# ADDENDUM No. 1

## RFP No. 23-59

### East Medical Center Drive Bridge Rehabilitation and Widening Project

DRAWING NO. 2021-008-UT6

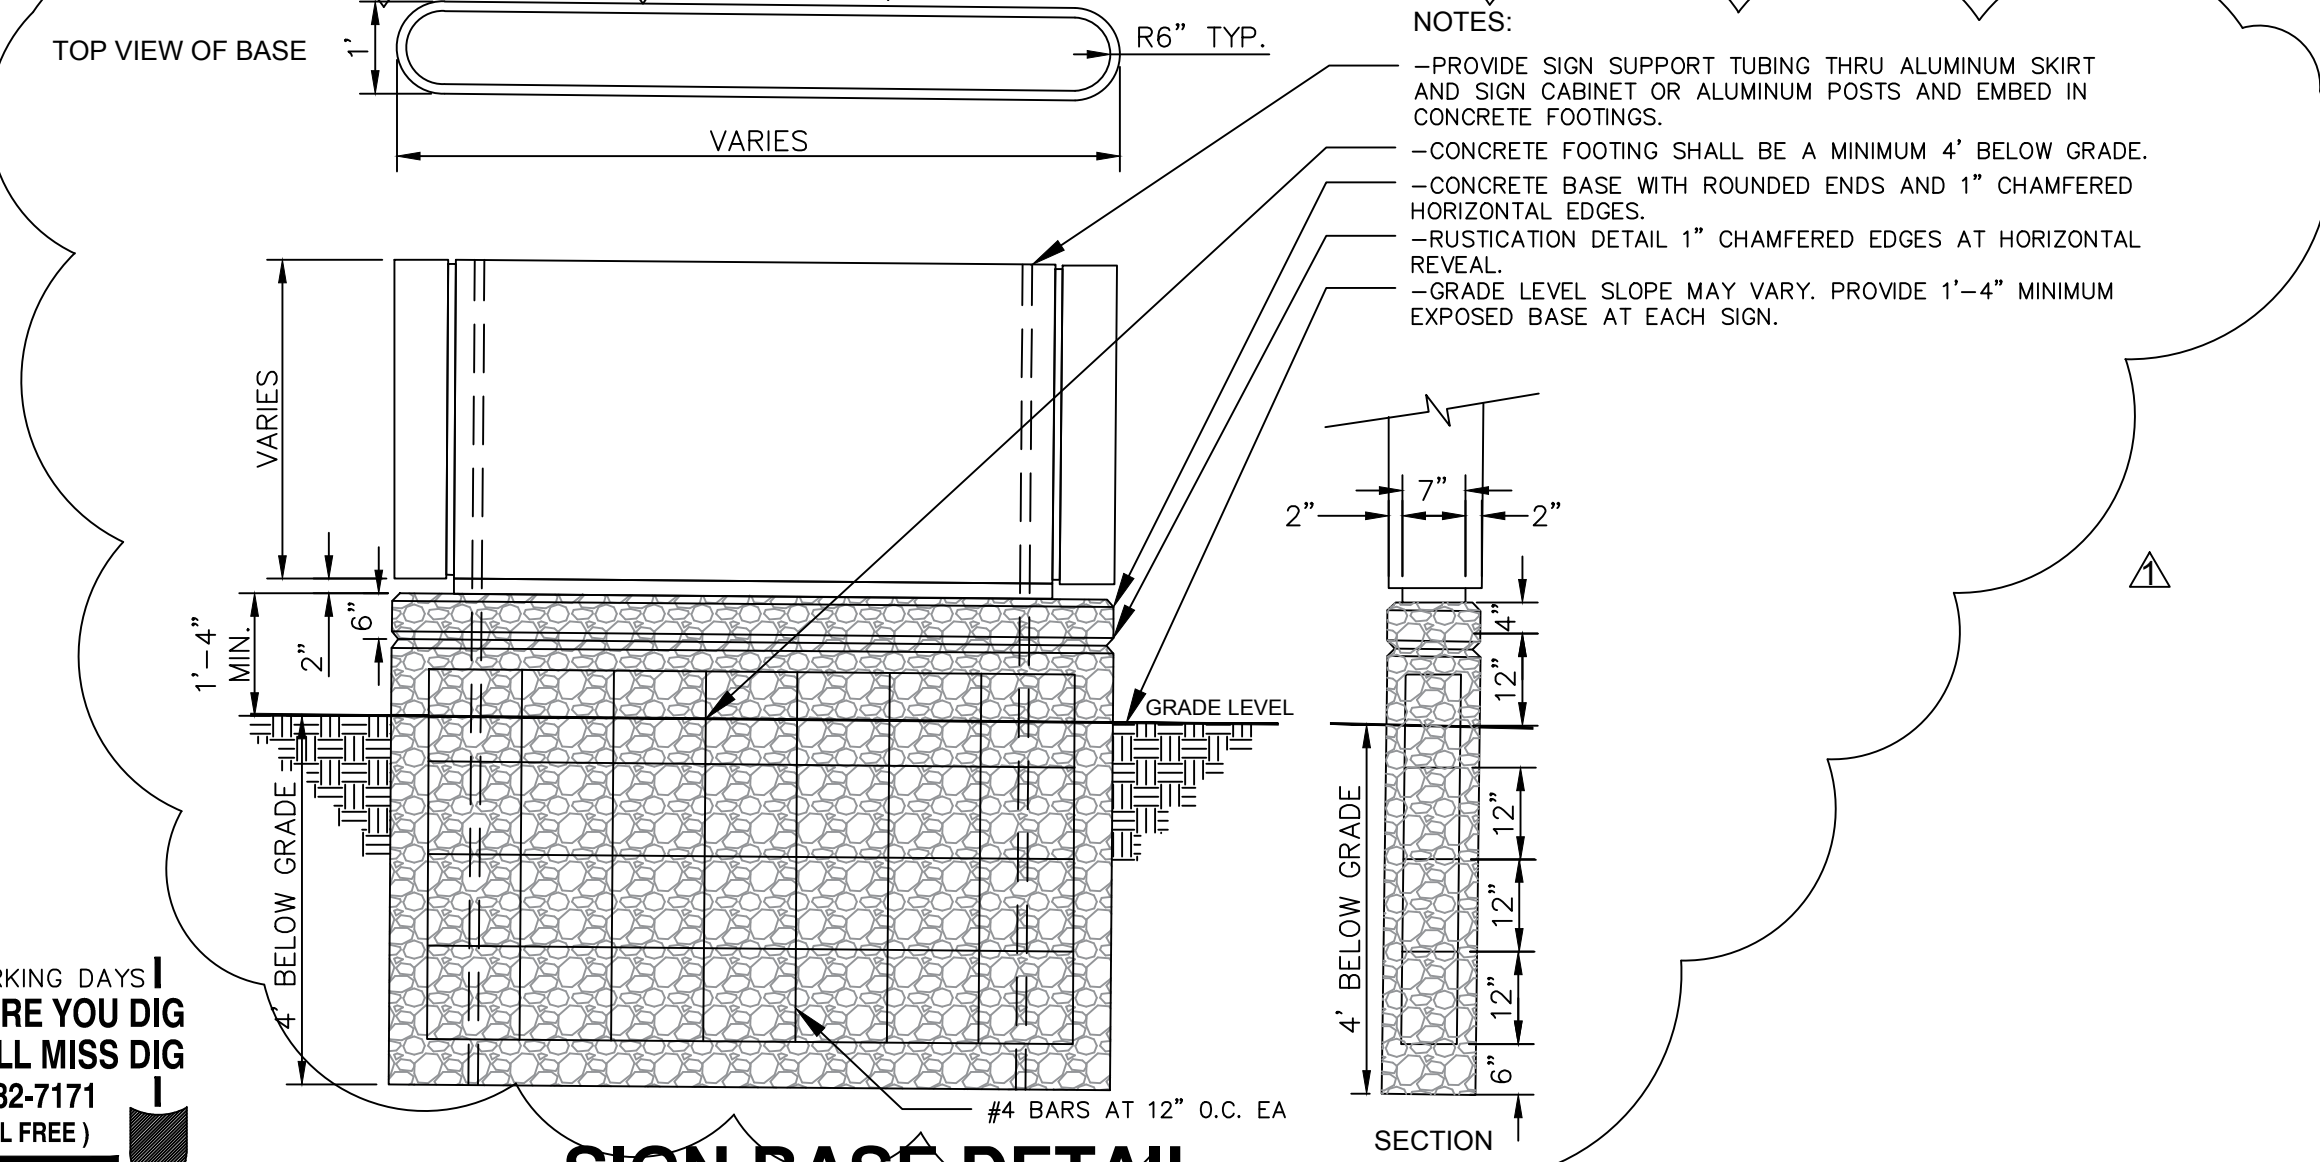
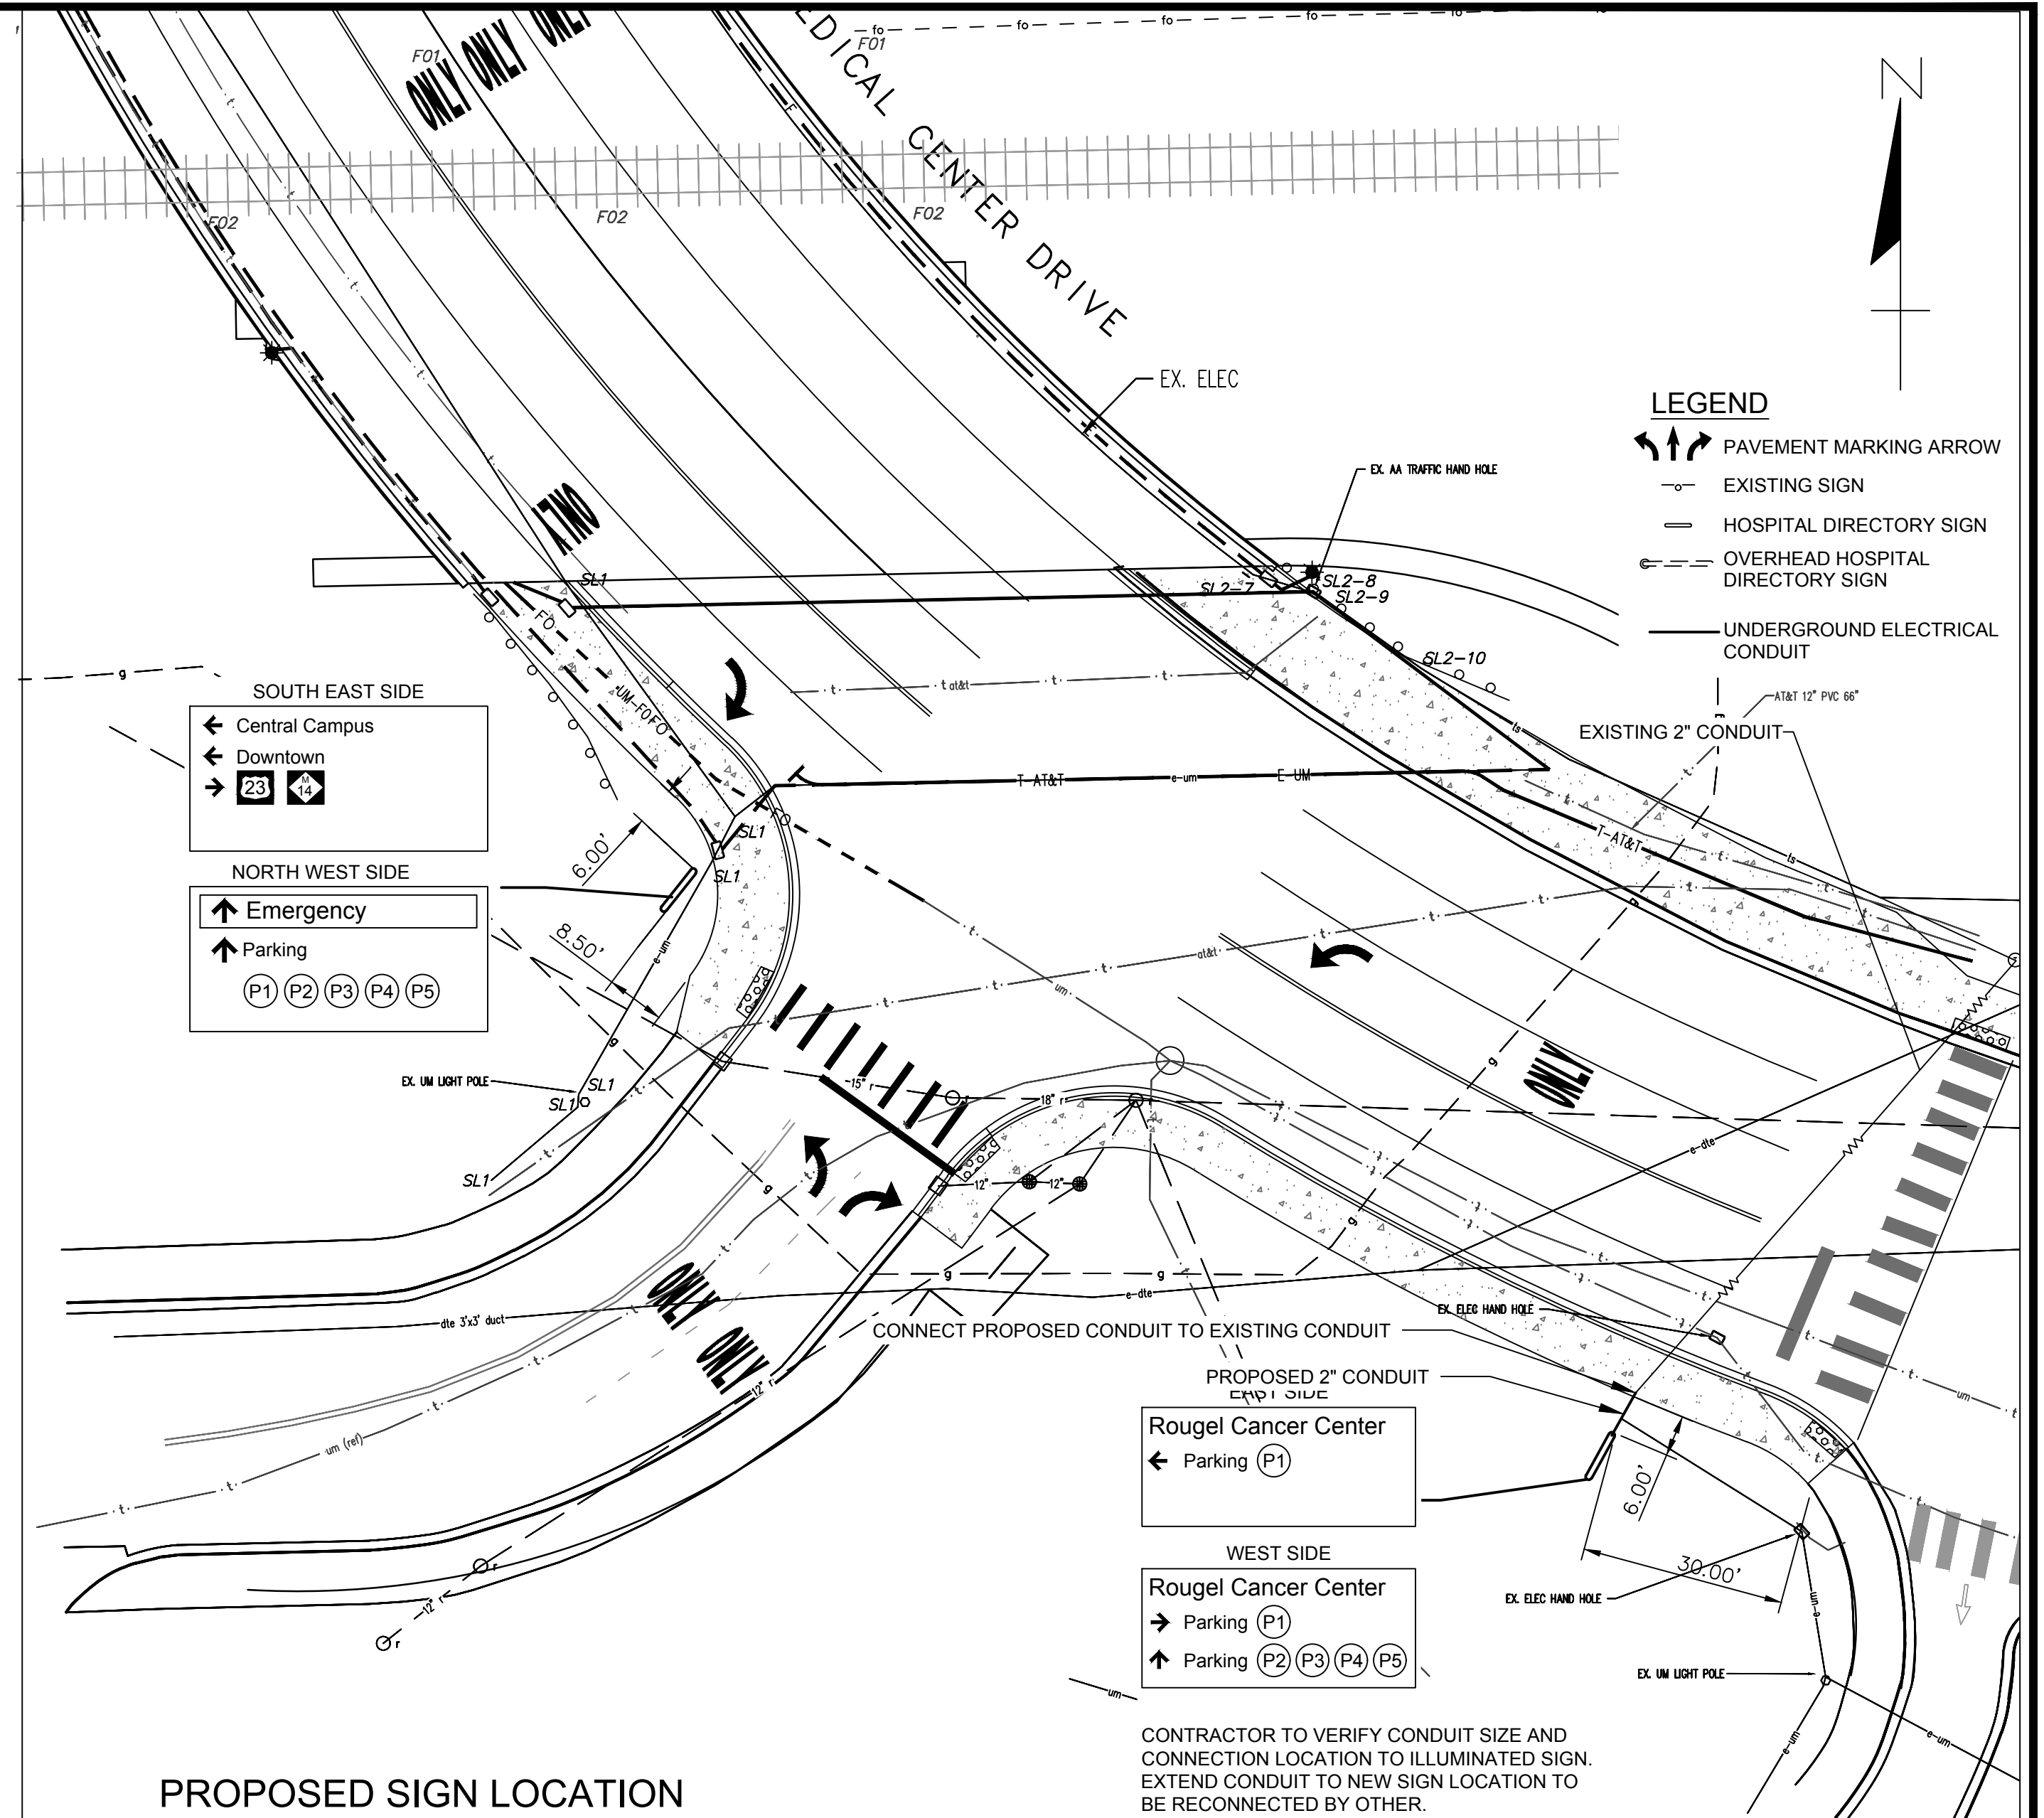
Question 28: Street light phasing plan, Note 8 states: UM TO PULL WIRING THROUGH UM SCHEDULE 80 PVC CONDUITS, CONTRACTOR TO COORDINATE WITH UM  
- there are no UM schedule 80 conduits in this drawing. Please confirm if the intention is for UM to pull their lighting cables from the sign to UM HH #6 in the noted schedule 40 conduit.

Street light phasing plan, Note 2 states: CONTRACTOR TO INSTALL SCHEDULE 80 PVC CONDUIT FROM EXISTING CITY OF ANN ARBOR HAND HOLE THROUGH CITY OF ANN ARBOR HH#2 AND TERMINATE IN CITY OF ANN ARBOR HH#4...

Answer 28: Note 8 has been updated to "...schedule 40 PVC conduits...". Note 2 has been updated to "...schedule 40 PVC conduit...".
